# COMPLETE REVISION HISTORY TO THE 2015 I-CODES<sup>®</sup>

**Complete Revision History to the 2015 I-Codes: Successful Changes with  
Public Comments: 2015 IBC**

**FIGURE 722.5.1(2)**  
**GYPSUM WALLBOARD PROTECTED STRUCTURAL STEEL COLUMNS WITH SHEET STEEL COLUMN COVERS**

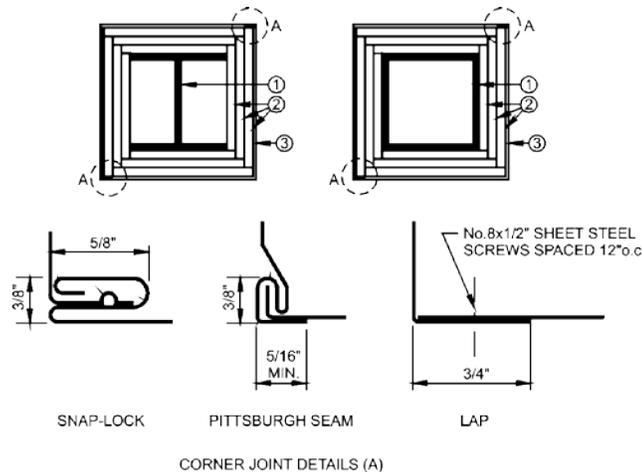
**722.5.1.2.1 Attachment.** The gypsum wallboard or gypsum panel products shall be supported as illustrated in either Figure 722.5.1(2) for fire-resistance ratings of 4 hours or less, or Figure 722.5.1(3) for fire-resistance ratings of 3 hours or less.

**FIGURE 722.5.1(3)**  
**GYPSUM WALLBOARD PROTECTED STRUCTURAL STEEL COLUMNS WITH STEEL STUD/SCREW ATTACHMENT SYSTEM**

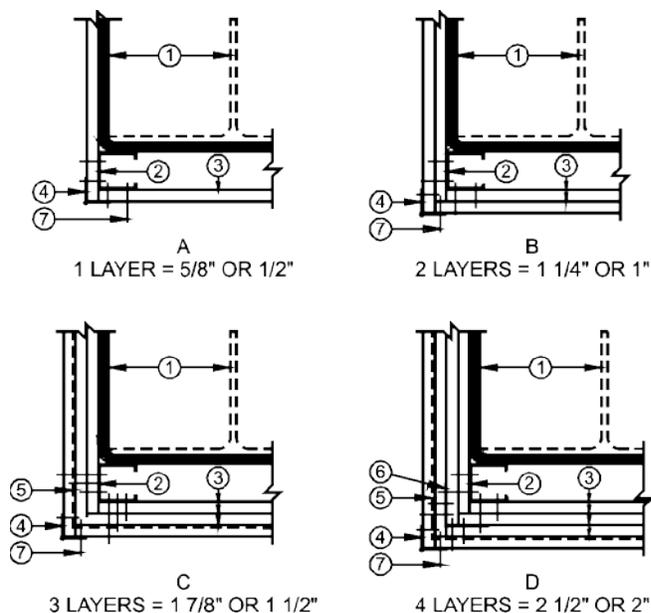
cover. The lap joints shall be secured with 1/2-inch-long No. 8 sheet metal screws spaced 12 inches on center. The column covers shall be provided with a minimum expansion clearance of 1/8 inch per linear foot between the ends of the cover and any restraining construction.

**FIGURE 3007.7.5  
FIRE SERVICE ACCESS ELEVATOR SYMBOL**

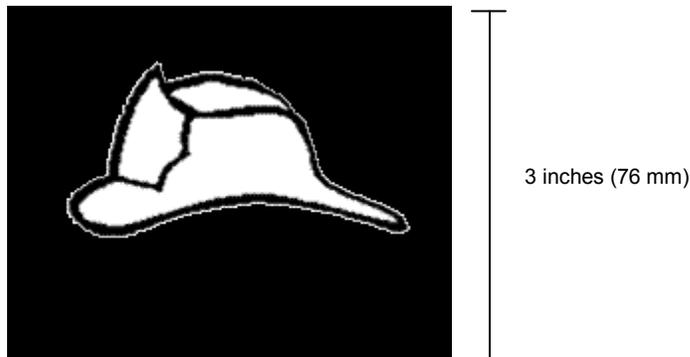
*(Add dimensional lines on Figure 3007.7.5 to indicate that it is the rectangular field, not the helmet that has a dimension of 3 inches (76 mm) minimum height.)*

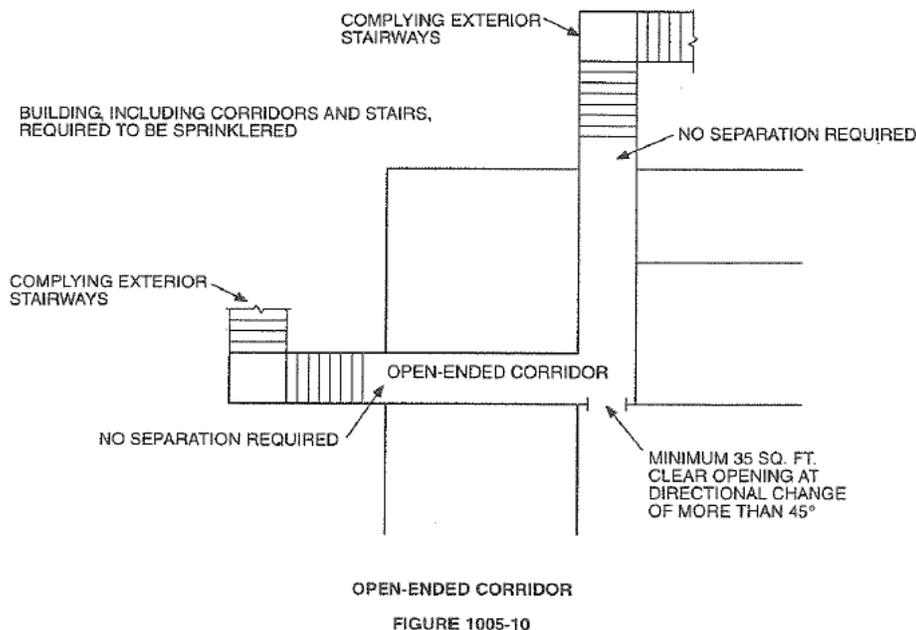
So, if the walls on each side of the stair have to be protected, how can a large opening where the door occurs be removed and have an unprotected connection to the interior corridor.

**FIGURE 2308.3.2(1)**  
**BRACED WALL LINE TOP PLATE CONNECTION**

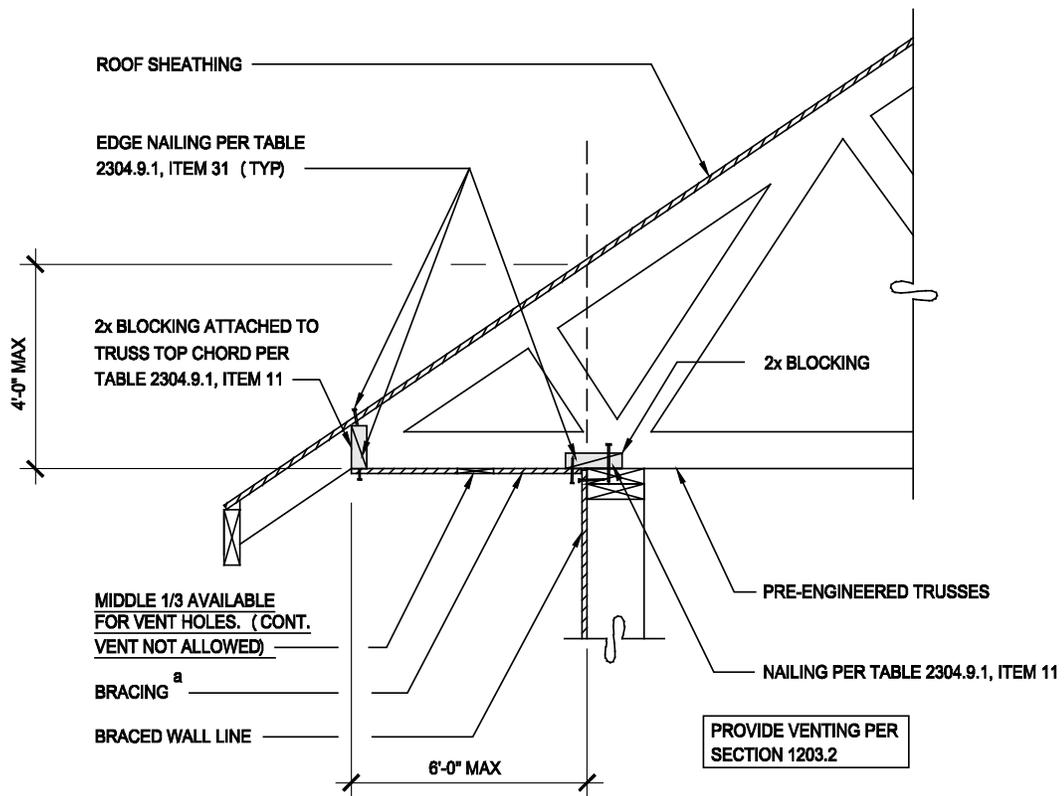
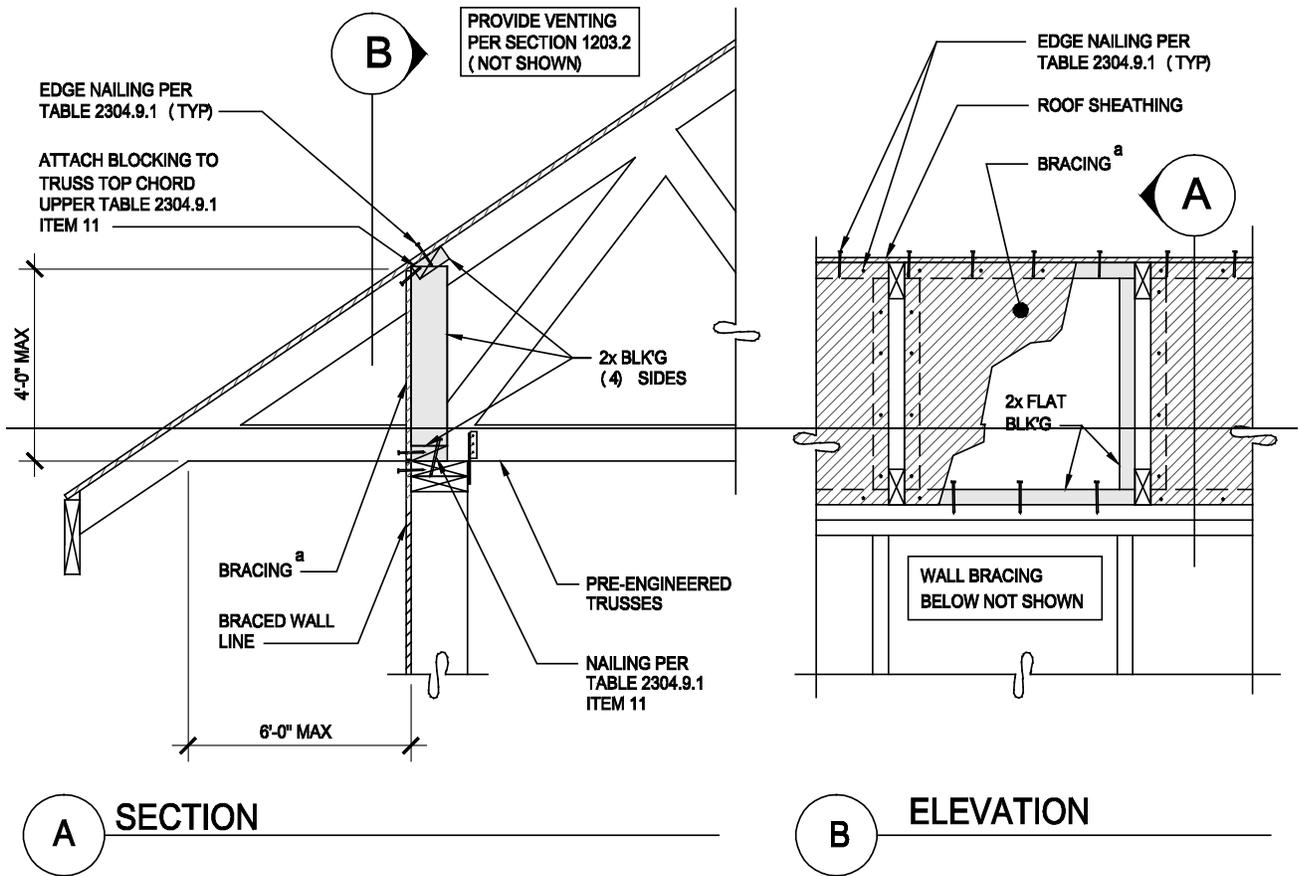
**Commenter's Reason:** The original proposal, as submitted, addresses a construction condition that is becoming much more common with an increase in the use of cantilevered and high-heel trusses. Cantilevered trusses are often incorporated to create a covered entry way for a portion of a wall line. Additionally, high-heel stub trusses are becoming more common to accommodate deeper attic insulation to meet increased energy-efficiency requirements. The concern regarding the lack of load path from the roof diaphragm to the braced wall line is illustrated in the example below from the publication, *Analysis of Irregular Shaped Structures: Diaphragms and Shearwalls*, McGraw/Hill – ICC 2011,

**FIGURE 2308.9.3.2  
ALTERNATE BRACED WALL PANEL ADJACENT TO A DOOR OR WINDOW OPENING**

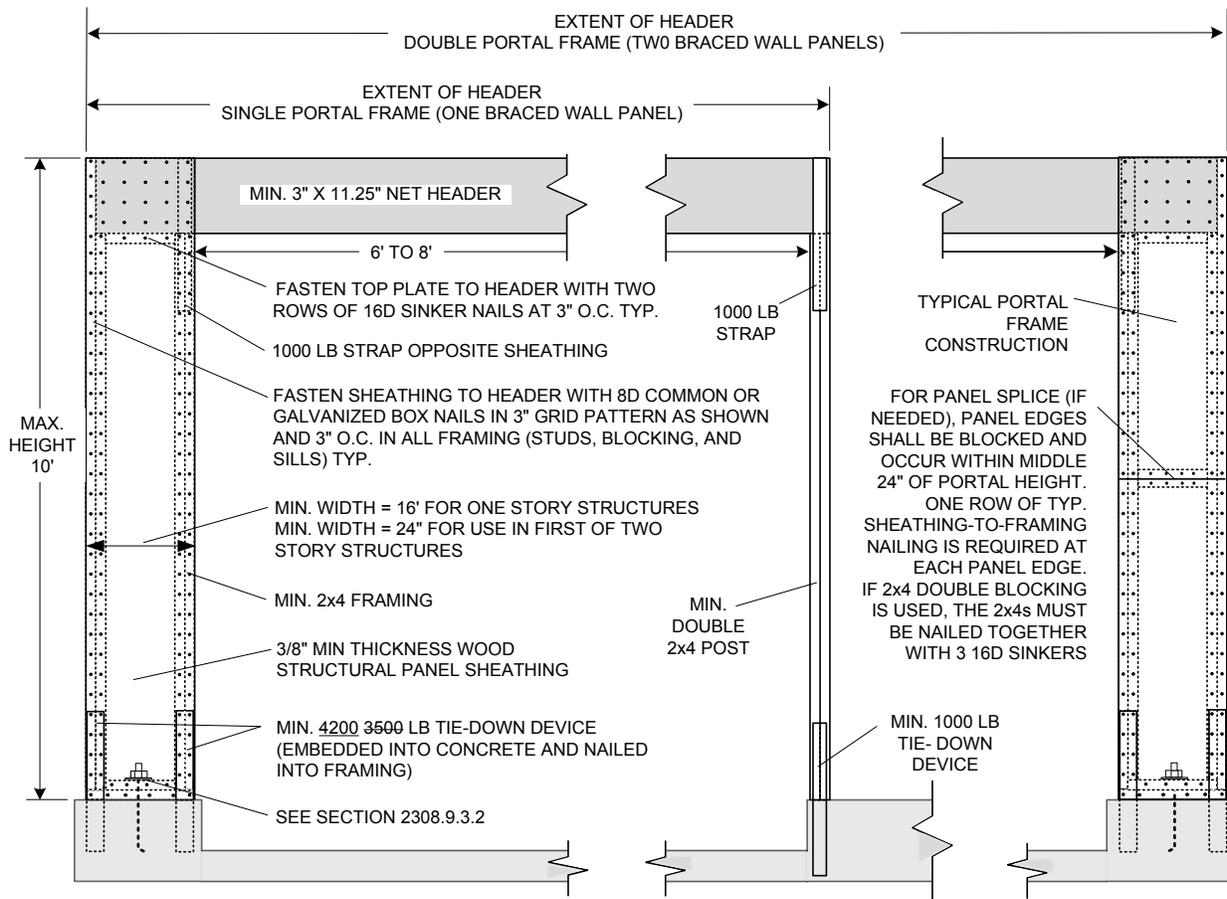
5/8 inch (15.9 mm) diameter and installed in accordance with Section 2308.6 shall be provided in the center of each sill plate. The studs at each end of the panel shall have a tie-down device fastened to the foundation with an uplift capacity of not less than 4,200 ~~3,500~~ pounds (18 480 ~~15 570~~ N).
